## Abstract

The design of a daisy chain battery system, while fairly straightforward, has a number of design elements that can become obstacles to implementation. This case study provides a glimpse into the questions and responses in the development of one daisy chain system.

The ISL78600 and ISL78610 are Li-ion battery manager ICs that supervise up to 12 series connected cells. The parts perform accurate monitoring, cell balancing and extensive system diagnostics functions. The devices communicate to a host microcontroller via an SPI interface and to other ISL78600, ISL78610 devices using a robust, proprietary, 2-wire daisy chain system.

FIGURE 1. INITIAL VBAT CONNECTION

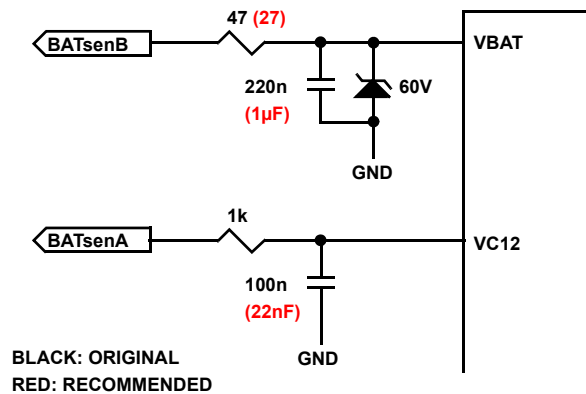
The VBAT input resistor was not damaged. Attached is a schematic of the VBAT connection.

Normally, we recommend a 27Ω resistor. While a 47Ω resistor may be OK, what happens is that the voltage at the VBAT pin drops when there is higher current, like during SPI or daisy chain communications. If the voltage drops too much, then there is not enough headroom on the front end analog circuits and there can be measurement errors. So, if the input resistor is not damaged then try a 27Ω resistor to see if this makes a difference.

If a smaller resistor value does not make a difference, then check that there is no large voltage differential across the VBAT series resistor. There should be a small drop in voltage (up to about 80mV), however, if there is more than this, check the diode. If the diode is OK and there is still a voltage drop across the resistor, then the part may be damaged.

The schematic shows two connections to the top of the stack, one for VBAT and one for VC12. This is OK, however, check to see

if there is a fault condition. If the BATsenB wire is broken, it could affect the measurement accuracy, however, this would also show up as an open VBAT fault.

Another recommendation we make on the input filters is that the time constants on all inputs be the same (or about the same). In this case, the cell input time constant is about 16 times the VBAT time constant. If there are high voltage transients on the pack voltage, the differential time constants will result in high voltage differentials on the IC input pins. To minimize this, we recommend different filter values, as shown in RED in [Figure 1 on page 2](#).

FIGURE 6. CUSTOMER ORIGINAL DAISY CHAIN CONTROL CONNECTIONS

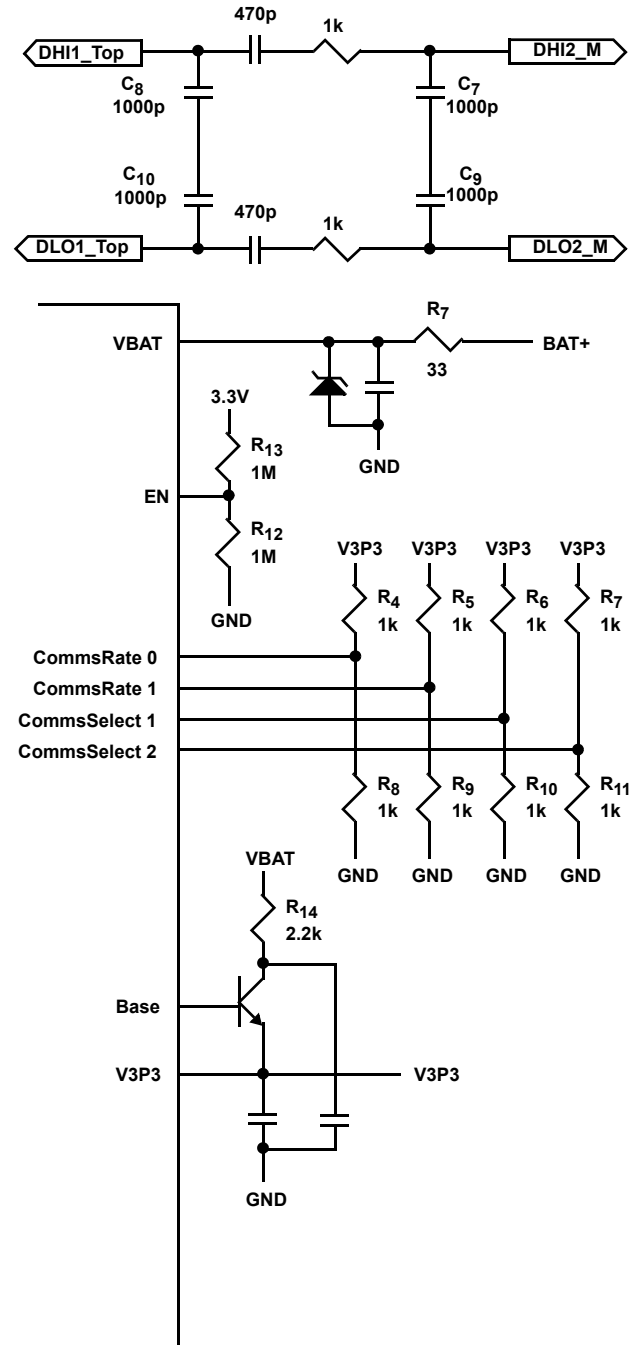
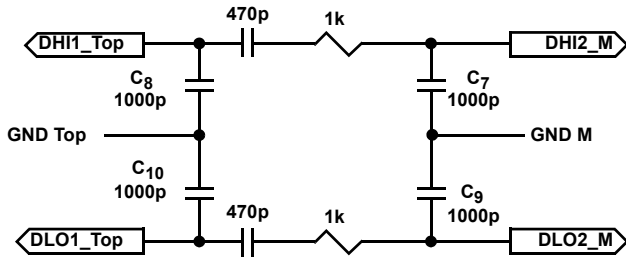
Below (Figure 6) is a schematic of the ISL78600 daisy chain and control circuits in my battery management system.

Resistor  $R_{12}$  is not loaded and the Comms pull-up/pull-down resistors are loaded according to the configuration settings above. I measured the voltage across the resistor,  $R_7$ , in the schematic. The master bottom device is currently reading 11.9mV (360 $\mu$ A) and the top device is currently reading 2.4mV (72 $\mu$ A). Neither of these currents are popping off the datasheet to tell me what is going on.

The first thing to notice on the schematic is that the center point of the capacitors C<sub>8</sub> and C<sub>10</sub> (and C<sub>7</sub> and C<sub>9</sub>) should be at the respective IC GND (see [Figure 7](#)).

If there is a cable between the two devices, then there should be a different arrangement of isolation components, though it will still work this way. The extra components are to protect the system in case of a cable short to chassis and to provide higher ESD immunity.

1. Resistor R<sub>14</sub> is probably too big. This will work OK for stand-alone, however, because of higher currents in the Daisy Chain mode, it might cause the 3.3V supply to drop out during communications. In our designs, we use a 100 $\Omega$  resistor.
2. On the V3P3 regulator, the collector resistor R<sub>14</sub> is shown to connect to VBAT. This should connect to BAT+, otherwise the V3P3 current will also flow through R<sub>7</sub>, reducing the VBAT voltage.

The observation that current across R<sub>7</sub> is only 360 $\mu$ A indicates that the device thinks it is a stand-alone device (i.e., Comms Select pins both at 0). Please check this.

FIGURE 8. CUSTOMER REPORTED CORRECT STAND-ALONE COMMUNICATION

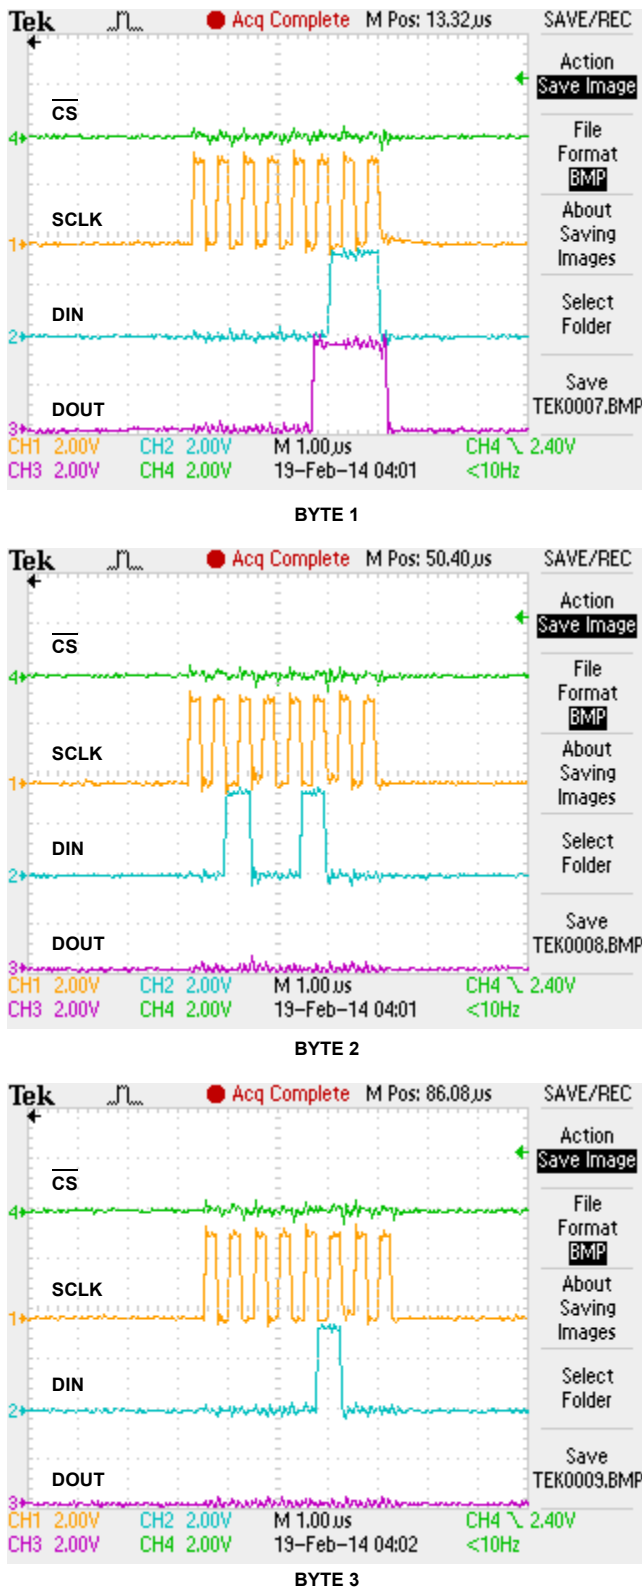
[Figure 8 on page 9](#) shows the SPI Identify command. The MISO data looks like 0x070000 but that's nothing valid to the best of my knowledge. If I send this command a few times in a row, I can get the MISO data to be 0x133800, which looks like a Comms Failure to me.

**A:** The fact that the upper device does not recognize the sleep/wake commands and there is no movement on the daisy chain lines means that there is something wrong with the daisy chain. *Nothing else matters until this can be cleared up.*

FIGURE 10. CUSTOMER DHI/DLO TRACES

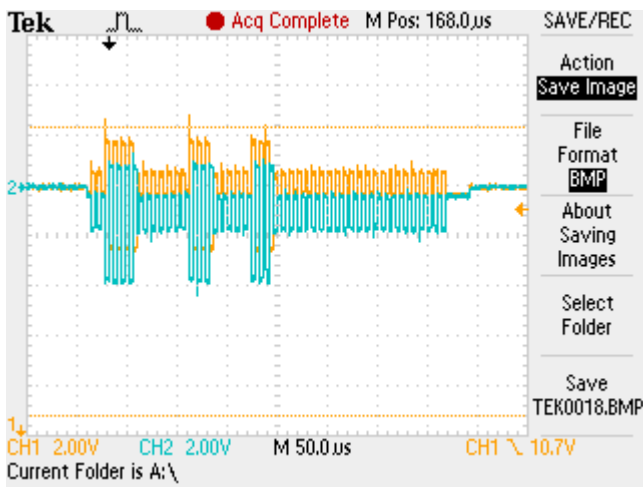
So, that looks good. [Figure 10](#) is the scope waveform for the master/bottom device's DHI2 and DLO2 lines, which actually look correct now while the daisy chain interface isn't connected. DLO2 is blue and DHI2 is orange.

The issue is that when I connected to the boards via the two daisy chain wires, the voltages on the master/bottom devices DHI2 and DLO2 go up to about ~22-23V.

**A:** The waveform in [Figure 10](#) looks almost correct for daisy chain communications, however, it is still not what you want to see. When the boards properly connect, you should see that the waveforms are more symmetrical vertically; and before and after the signals there should be an offset between the two traces (while here they appear to be the same voltage).

Since the voltages appear good before connecting the daisy chain wires, it looks like there is an isolation problem. Perhaps DHI2 and DLO2 on the top device are being connected to the DHI2 and DLO2 of the bottom device when you connect the two boards with the daisy chain wires. If so, then this would absolutely be a bad thing.

Check to make sure the top and bottom boards are completely isolated. Nothing on the top board should touch the bottom board, except the VSS of the top tying to the BAT+ of the bottom and the communications through the capacitors. The DHI2/DLO2 on the top board should be floating.

**FIGURE 12. CUSTOMER DAISY WAVEFORMS AFTER CHANGES (GOOD)**

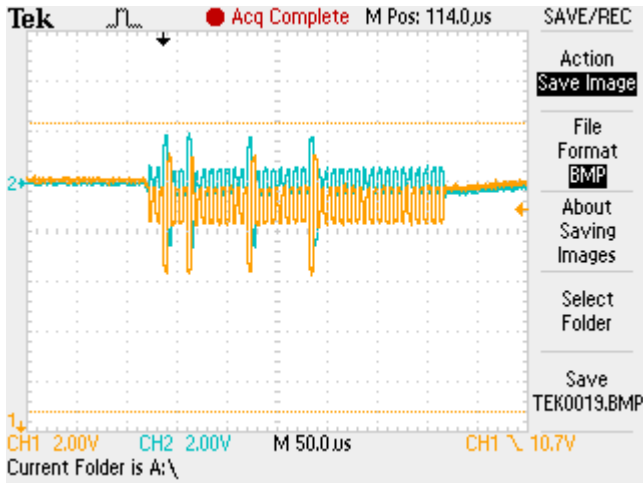
**Q:** Wow, it's been a long day. I think I finally got it right, however, I won't be able to check if valid data is coming back down the stack until tomorrow. [Figure 12](#) are two waveforms showing my daisy chain communication. What I sent you last time was just the master/bottom side, since connecting them had the isolation issue I described. Once I fixed the isolation issue, I connected the 2-wire daisy chain interface and captured the attached waveforms.

**A:** This looks better.

FIGURE 13. CUSTOMER BASE ID COMMAND (SPI)

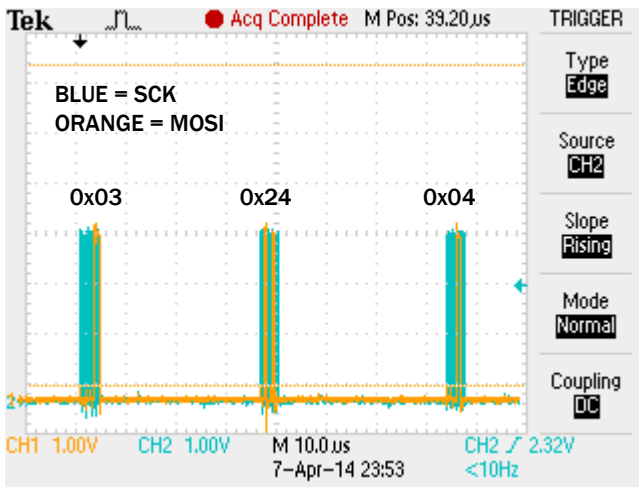
The 'base id command' waveform (Figure 13) shows the transmission of 0x03 24 04 from the Host MCU to the bottom/master device, specifically, the timing between SPI bytes in the overall transmission of this command. The timing shows that this command meets the 100 $\mu$ s maximum requirement defined as the  $\overline{CS}$  high time (the time between bytes). Please let me know if you see any concerns with the timing of my command transmission.

I went through some timing diagrams from tests I did a while ago and found a scope shot of an identify sequence from our board. See [Figure 15](#). You can see that our response to data ready (the "0" trace) is much faster than yours and is about 3-4 $\mu$ s delay from falling edge of data ready to the start of SPI communication.

We worked with our designers and got simulation results for the  $\overline{CS}$  to SCLK timing. As it turns out, there is a maximum time from the falling edge of  $\overline{CS}$  to the first rising edge of SCLK. This only

shows up on the IDENTIFY command, not on any other command. Simulations show that there can be data corruption in the IDENTIFY response if the  $\overline{CS}$  to SCLK time exceeds 50 $\mu$ s. We will be changing the datasheet to include a comment suggesting a maximum of 30 $\mu$ s (to cover corner conditions) between these two signal edges.

FIGURE 14. CUSTOMER DATA READY RESPONSE HANDLING TIMING

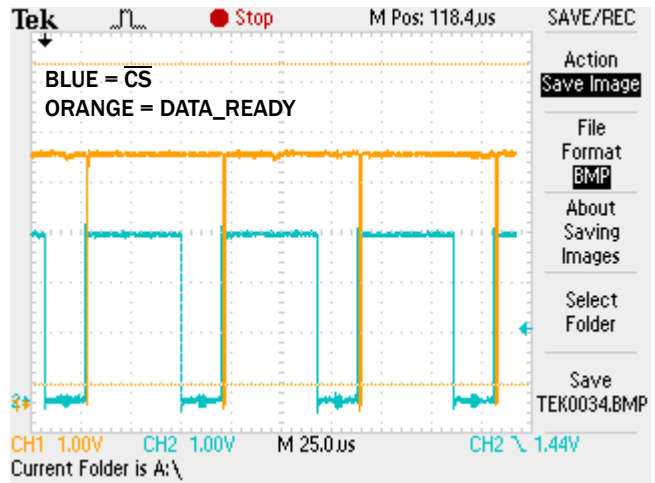
Also, the 'data\_ready response handling' waveform (Figure 14), shows the timing on servicing the  $\overline{DATA\_READY}$  line. Please note that I have a level shifter that inverts  $\overline{DATA\_READY}$  from the ISL78600. As shown in the waveform, the  $\overline{DATA\_READY}$  signal goes HIGH when a byte is available in the ISL78600 buffer. The time that  $\overline{CS}$  is low is the time it takes for me to read a SPI byte (~25 $\mu$ s). At the completion of each read with the rising edge of  $\overline{CS}$ , you can see  $\overline{DATA\_READY}$  dip low briefly and return HIGH, indicating another byte is available. The time from the rising edge of  $\overline{DATA\_READY}$  to  $\overline{CS}$  going low again is the time it takes for me to respond to the  $\overline{DATA\_READY}$  signal (~45-50 $\mu$ s). Do you think this is too long?
